**Re: Phillips 66 Propane Recovery Project Environmental Impact Report**

On behalf of the Rodeo Citizens Association, we submit these comments on the Final Environmental Impact Report ("FEIR") for the Phillips 66 Propane Recovery Project ("Project"). As set forth below, and in the attached report of Phyllis Fox, Ph.D., PE ("Fox Report"), Exhibit A, we have concluded that the EIR suffers from numerous deficiencies that render it inadequate under the California Environmental Quality Act ("CEQA") (Pub. Res. Code § § 21000 *et seq.*) and the CEQA Guidelines (14 Cal. Code Regs. § § 15000 *et seq.*) ("CEQA Guidelines"). We respectfully request that the Commission defer consideration of the proposed Project until such time as the EIR is revised to comply with CEQA.

Figure 2  
Proposed Refinery Fuel Gas System Block Flow Diagram

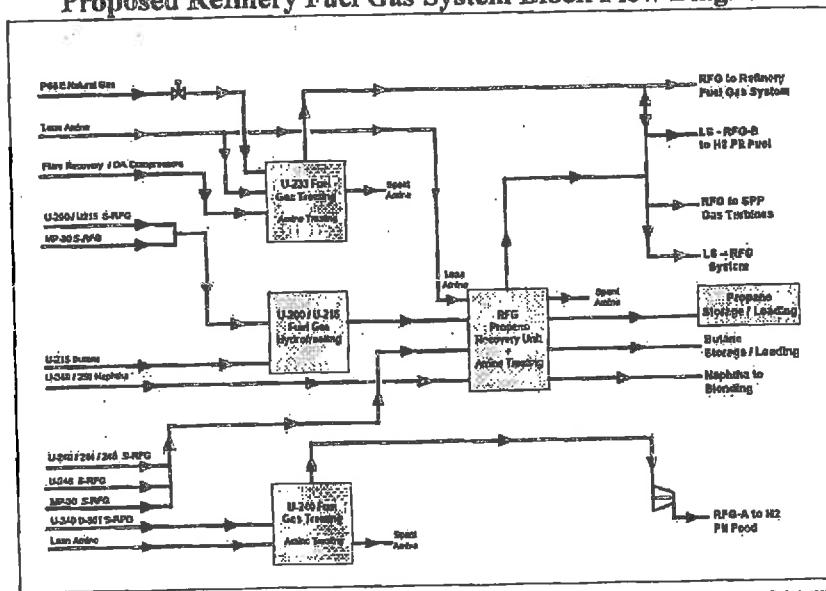
The RFG Propane Recovery Unit is the big yellow box in the middle of Figure 2. Blue arrows in the lower left hand corner of Figure 2 identify the inputs to this unit, which are various refinery streams. These streams include "U-240/244/248 S-RFG." This designation means that Refinery Fuel Gas (RFG) from Unit U-240 is sent to the RFG Propane Recovery Unit. (This stream was formerly sent to the U-240 Fuel Gas Treating Unit. DEIR, Fig. 3-5.) As Santa Maria Gas Oil (SMGO) is one of the inputs to Unit U-240, changes at the Santa Maria Facility would be transmitted directly to the Project via the U-240 Prefrac Unit.

This establishes a direct link between this Project and modifications at the Santa Maria Facility. This is the "nexus" to the larger project with the potential to change crude oil feedstocks.
